CITY COUNCIL Agenda

7. AMERICANS WITH DISABILITIES ACT BEACH ACCESS FEASIBILITY STUDY AND TRAIL CONNECTIVITY TO TAMARACK STATE BEACH FEASIBILITY STUDY – Adoption of a resolution accepting the Americans with Disabilities Act Beach Access Feasibility Study and the Trail Connectivity to Tamarack State Beach Feasibility Study, including the corresponding concept plans, and directing staff to prepare a request for proposals to pursue the environmental review, agency permitting, engineering and construction documentation phases of the projects. (Staff contact: Kyle Lancaster, Parks & Recreation and Nathan Schmidt, Public Works)

CONCEPTUAL PLANS FOR: ADA BEACH ACCESS AND TRAIL CONNECTIVITY FEASIBILITY STUDY CITY OF CARLSBAD, CALIFORNIA

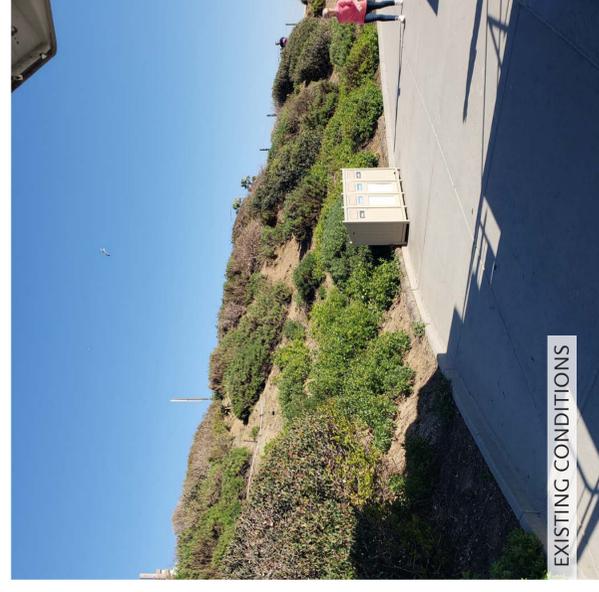
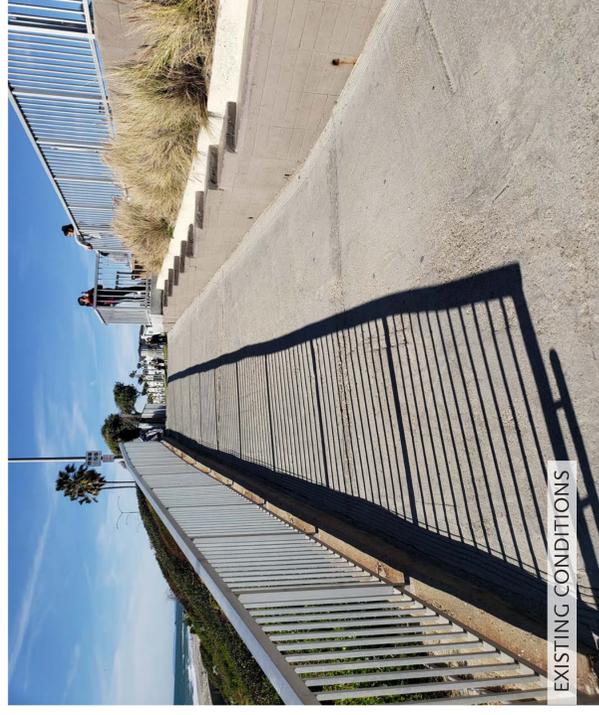
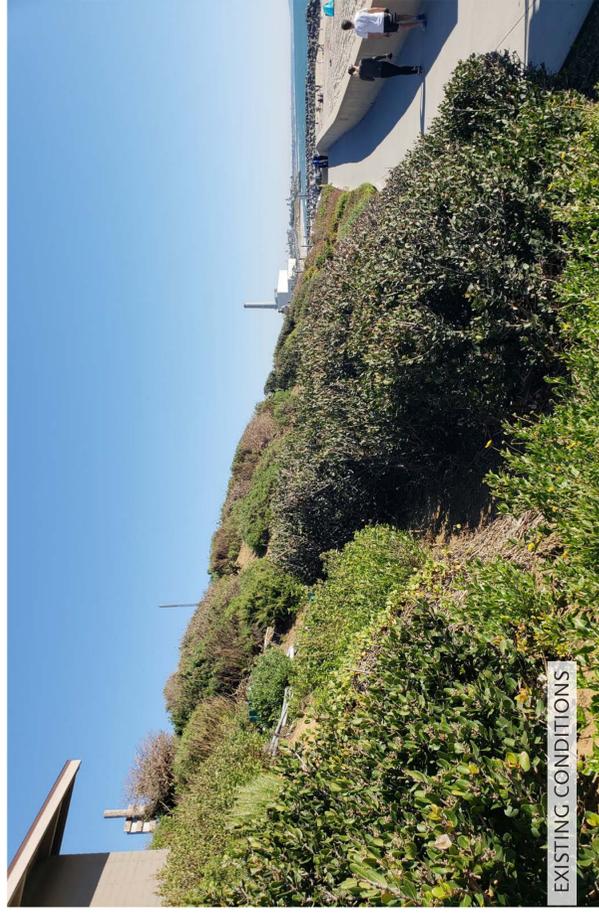
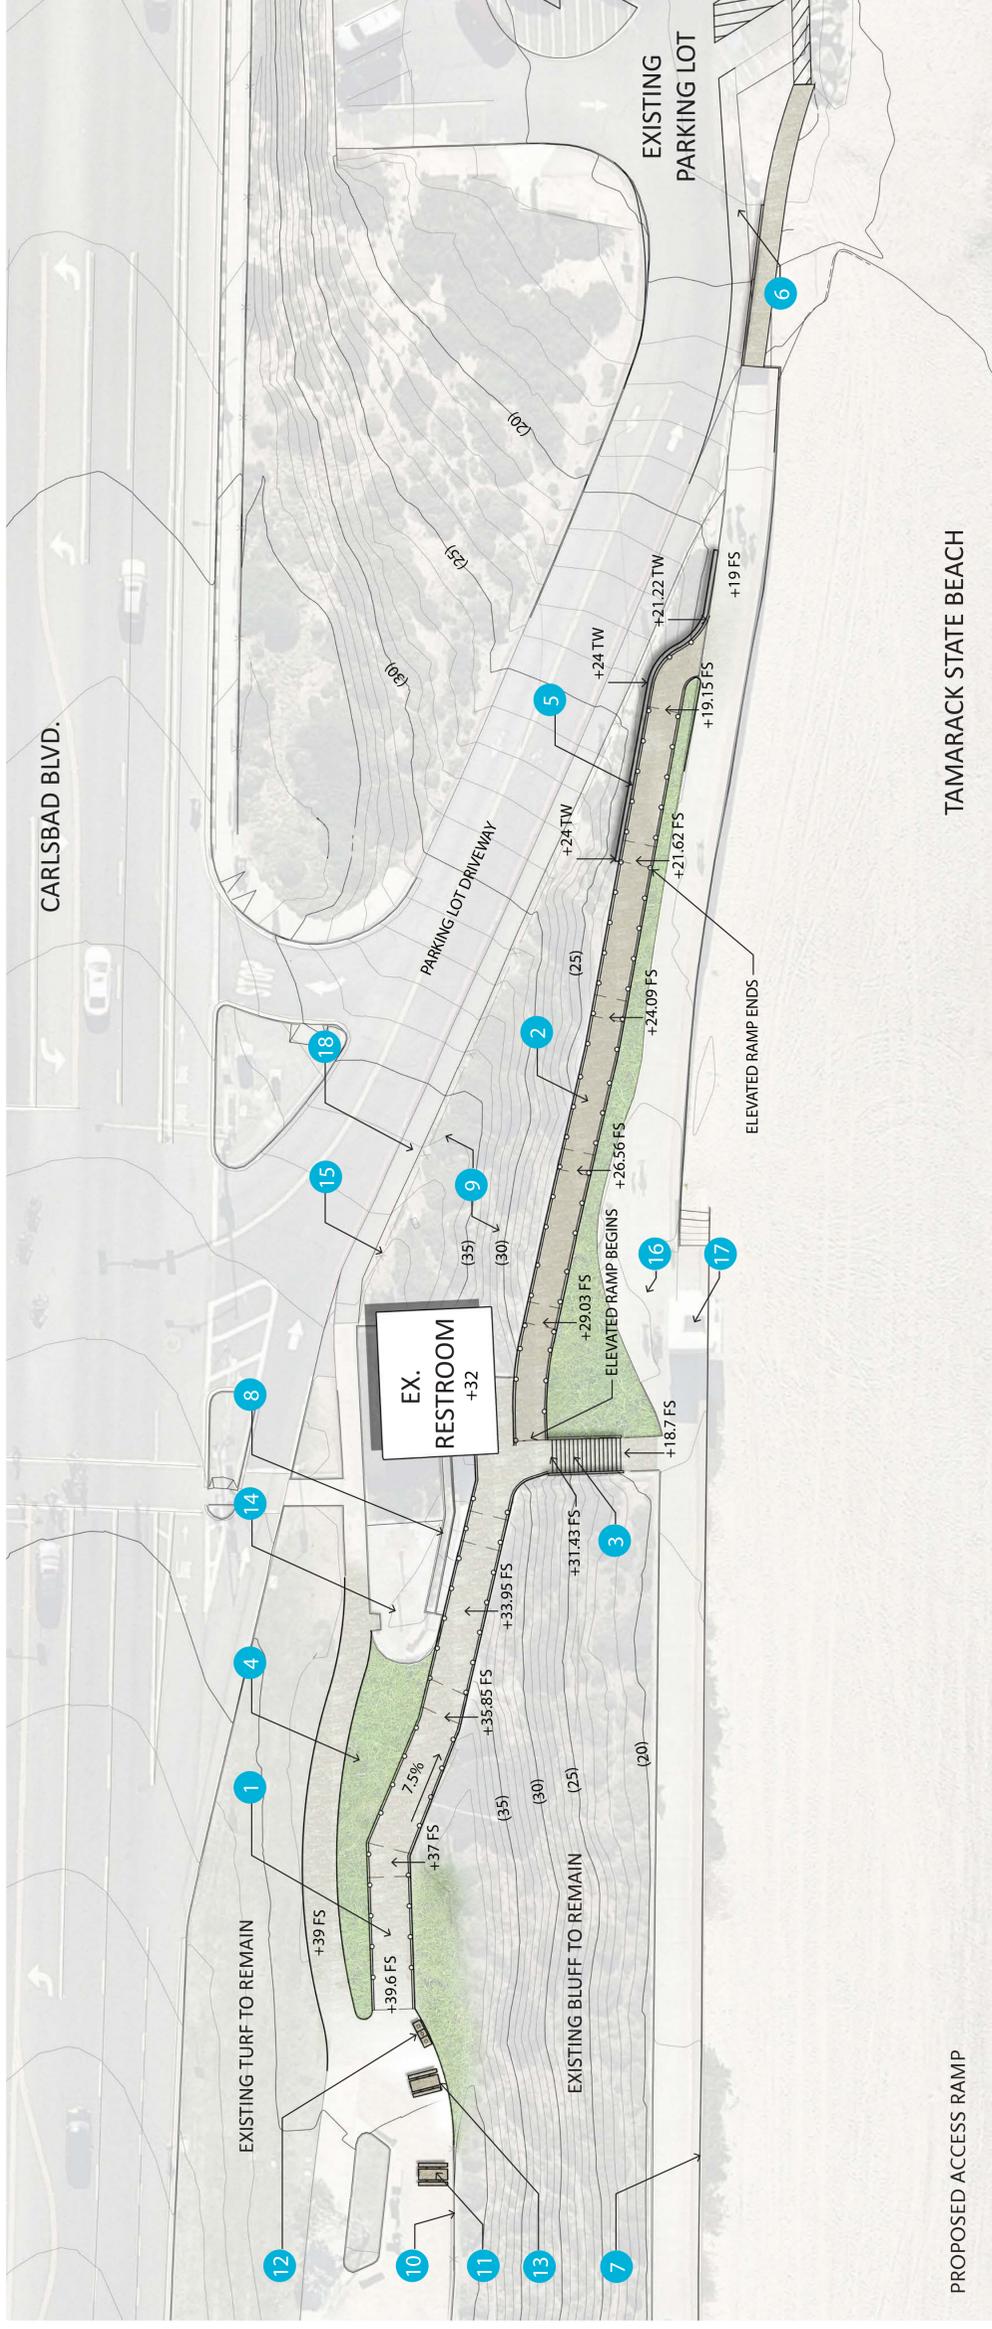
- Is the path beyond the end of the ramp (see 5 on sheet 3) concrete? Just sand? Will there be any curb, railing, etc. along that portion?
 - **Yes, the conceptual design proposes concrete for the at-grade path beyond the end of the ramp to tie-in to the concrete adjacent to the existing restroom. There is no curb, railing, etc. currently proposed for this at-grade concrete path. The proposed ramp is designed to go over the top of the existing rip-rap to minimize the amount of sand that would be impacted.**

- Where would existing showers be relocated to? (see 9 on Sheet 3) What is the extent of work required to achieve that (additional paved area, relocation of water line, new drainage)?
 - **The showers would be relocated approximately 55 feet to the south. The extent of work would include removal of existing paved area, replacement with new paved area, waterline relocation, and potentially a new sewer connection.**

Photo Simulation
Tamarack Beach Access

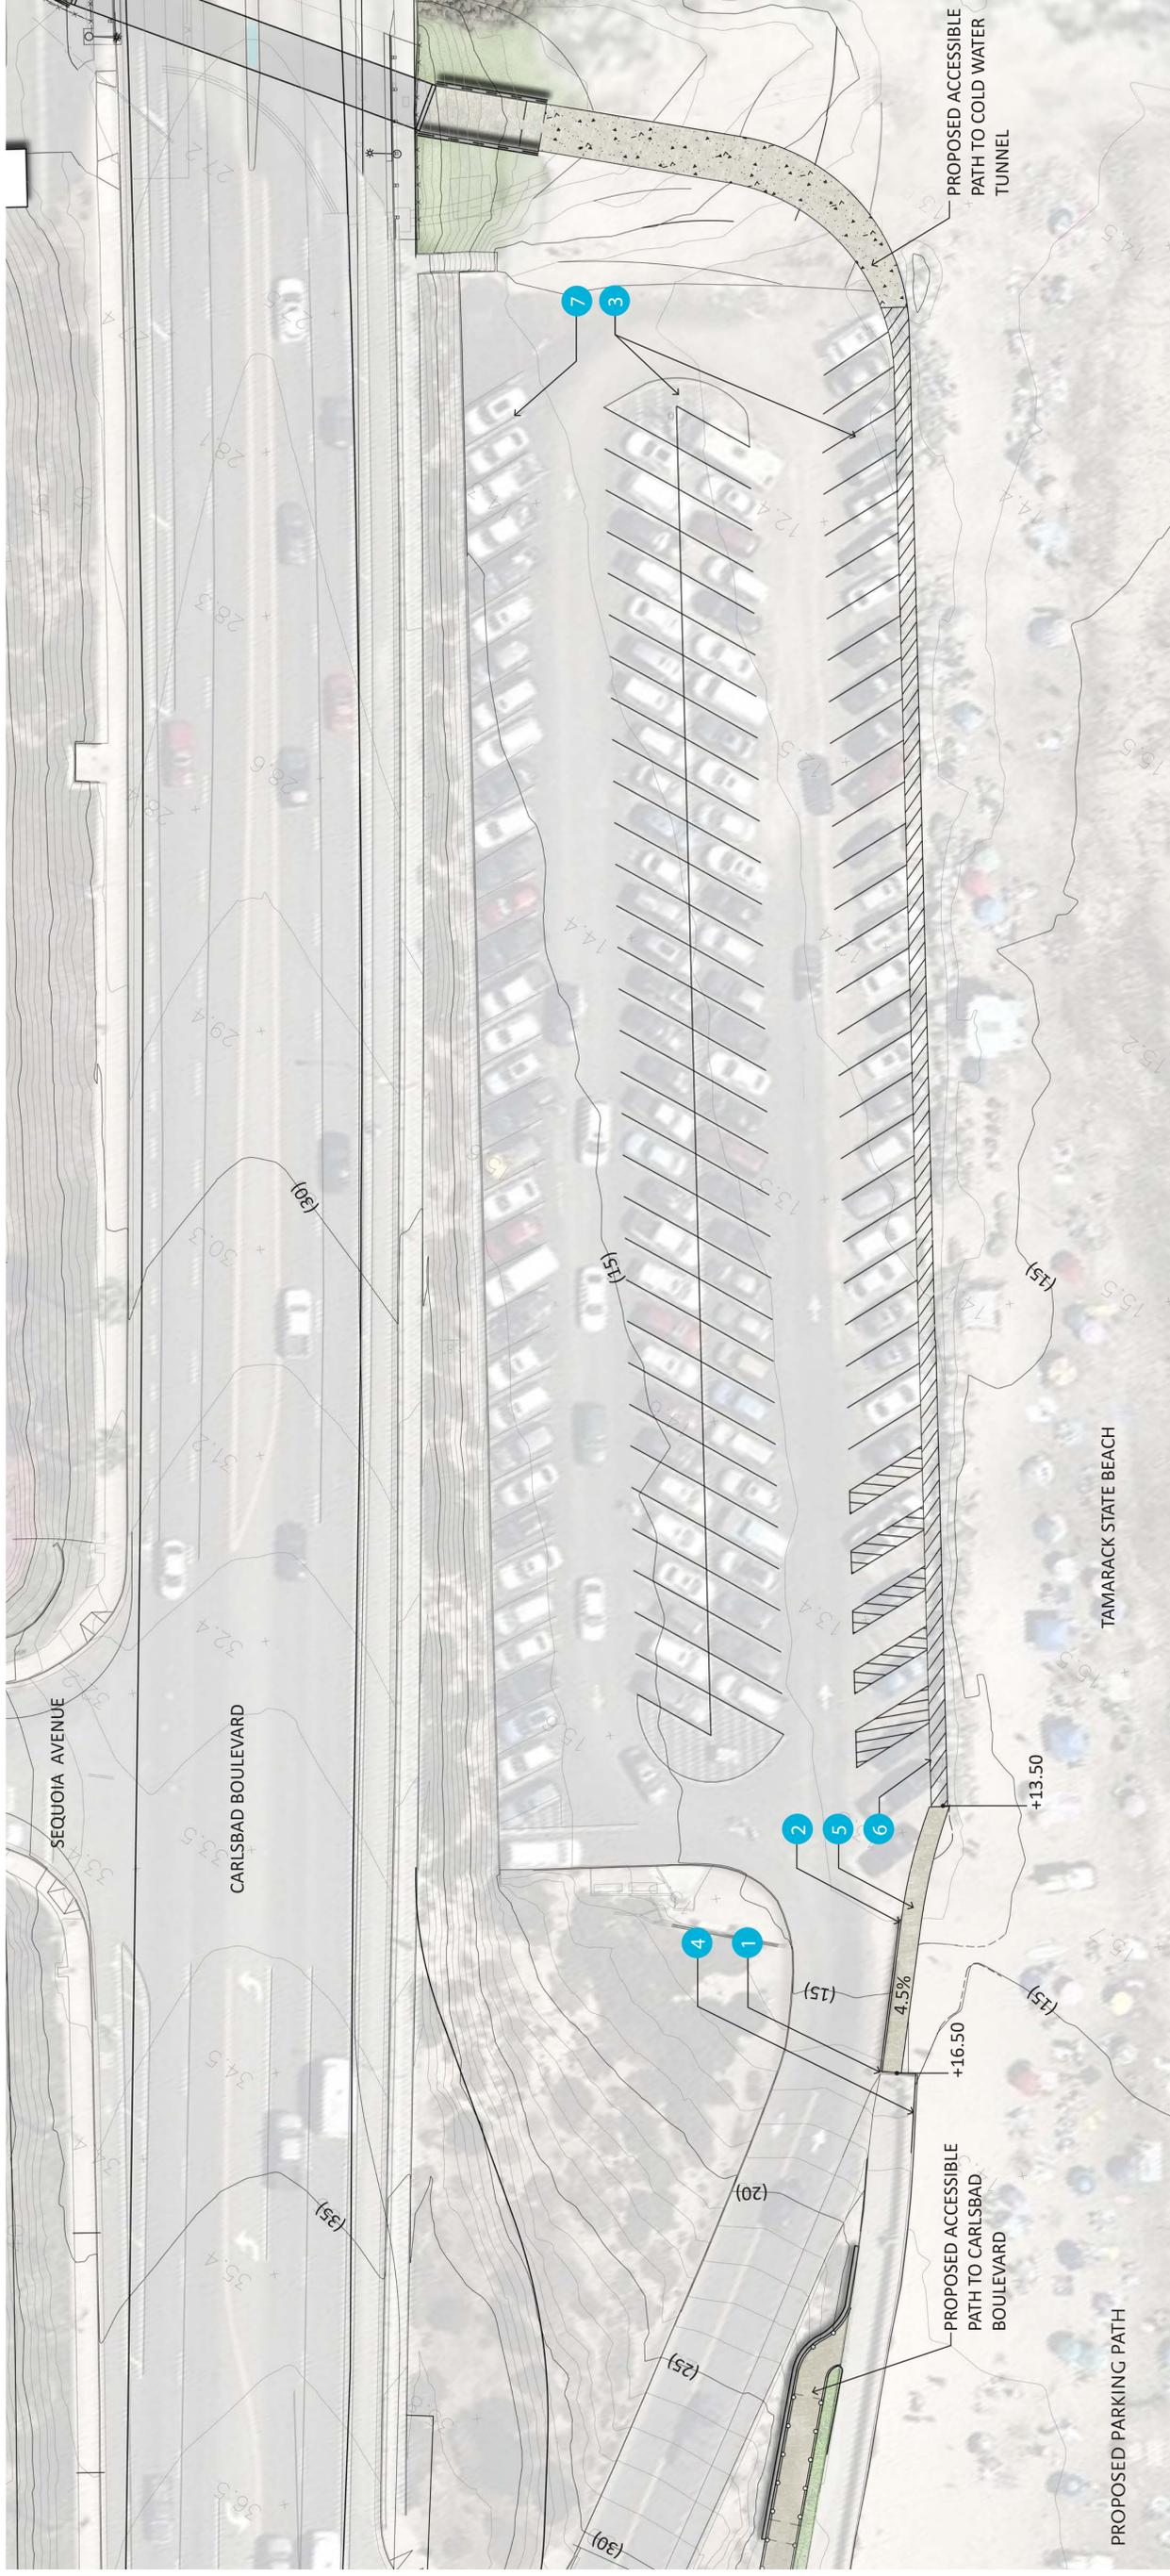
- Why is 10ft the appropriate width for the concrete ramp (see 1 on sheet 5)? The wooden portion of the ramp is only 8ft wide. What is the minimum width required for an ADA ramp?

- Is there any change in the footprint of the stairs (see 3 on sheet 5)?
 - **The proposed design will require no change to the footprint of the stairs.**

- Does the proposed accessible path to the parking lot (see 6 on sheet 5) extend concrete seaward of the existing limits of the parking lot? If so, why is it necessary? How much (sq. ft.) of sand area would be impacted? Can that be accommodated within the existing parking lot? Will there be any curb or railing along that portion?

- **This accessible path is actually part of the Cold-Water Tunnel project, not the Tamarack ADA ramp project. The accessible path would extend some concrete seaward (approximately 350 SF). This path is necessary to allow for ADA access from the bottom of the ramp/end of the lower sea wall to the sand. Currently, there is no ADA accessible path of travel from the end of the lower sea wall to the sand. A railing may be appropriate for this short ramp. The idea is to extend an ADA path of travel to the proposed Cold-Water Tunnel (see sheet 7 of the conceptual plan set).**

Tamarack Parking Access

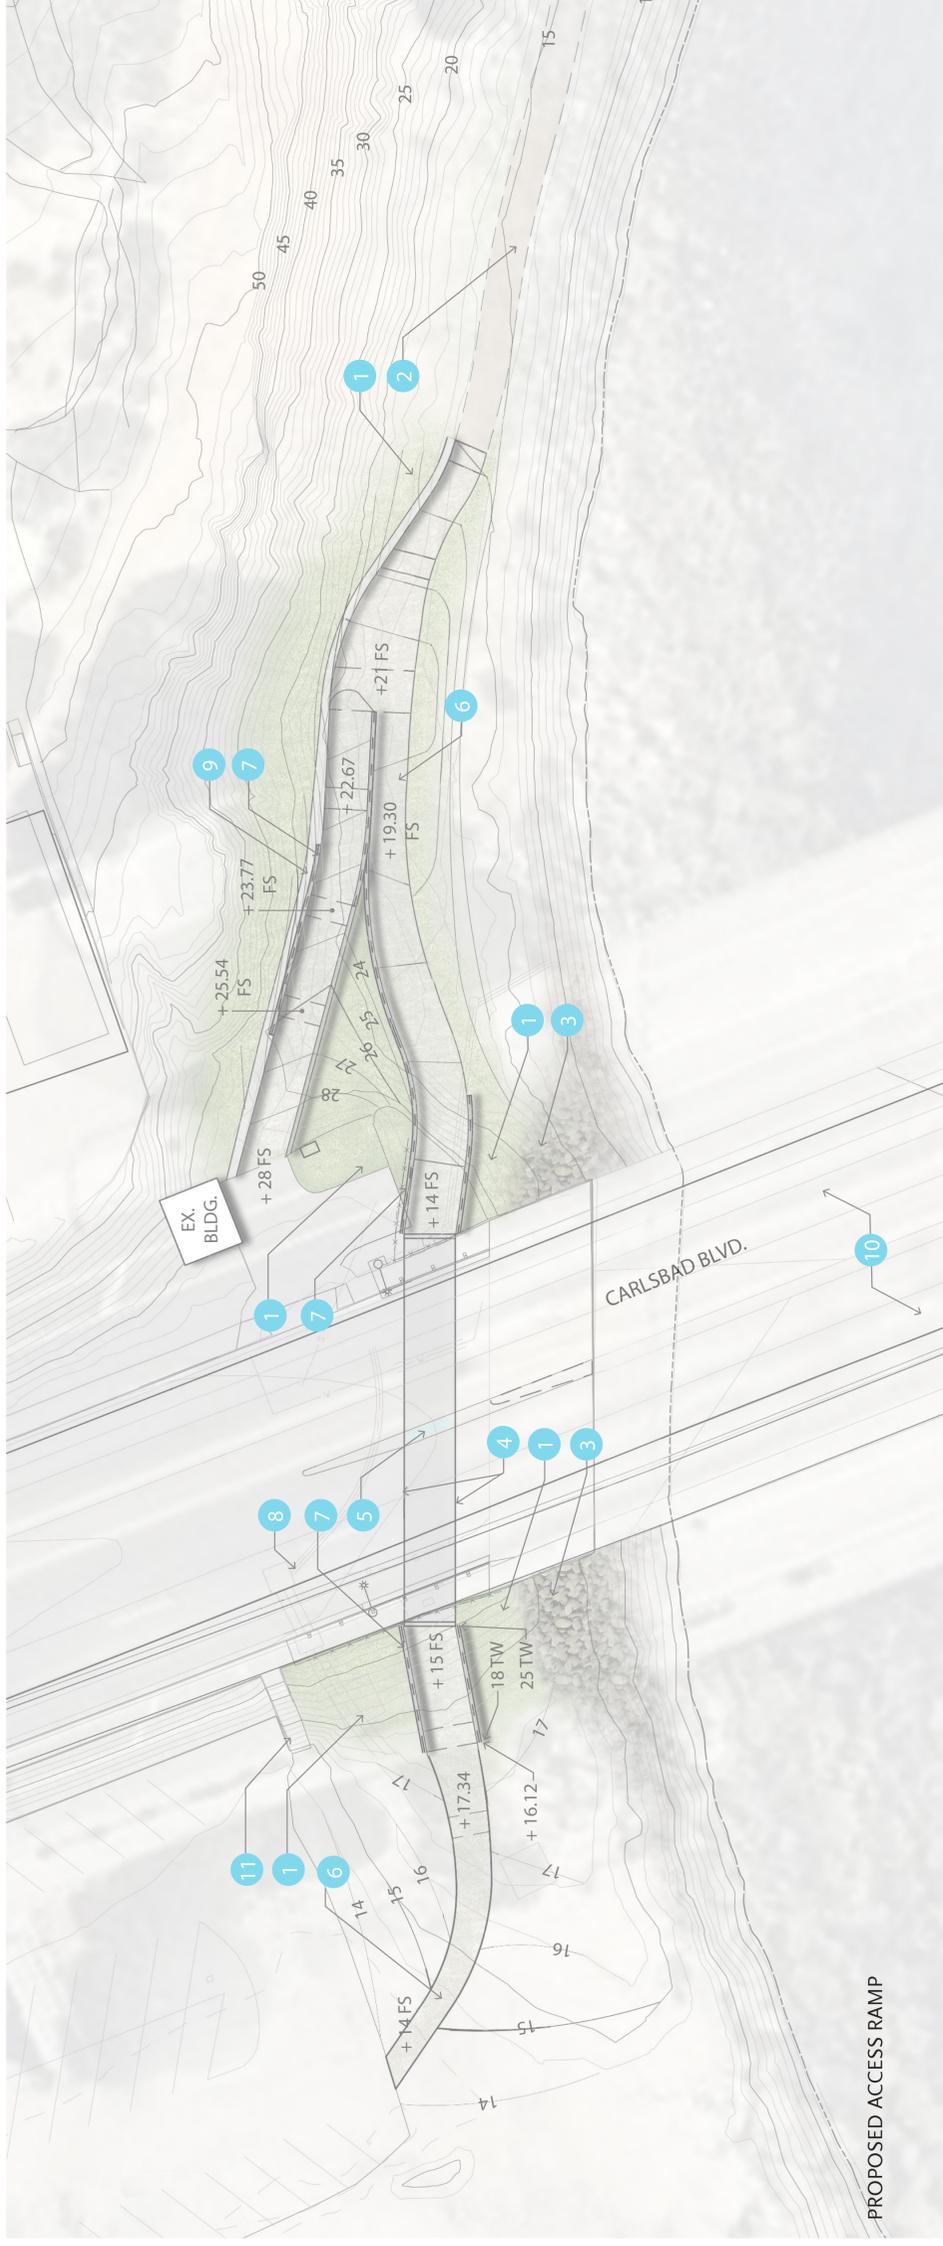
- How wide is the proposed box culvert (see 4 on sheet 7) and the proposed concrete ADA ramp (see 6 on sheet 7)? What is the minimum width required for ADA access?
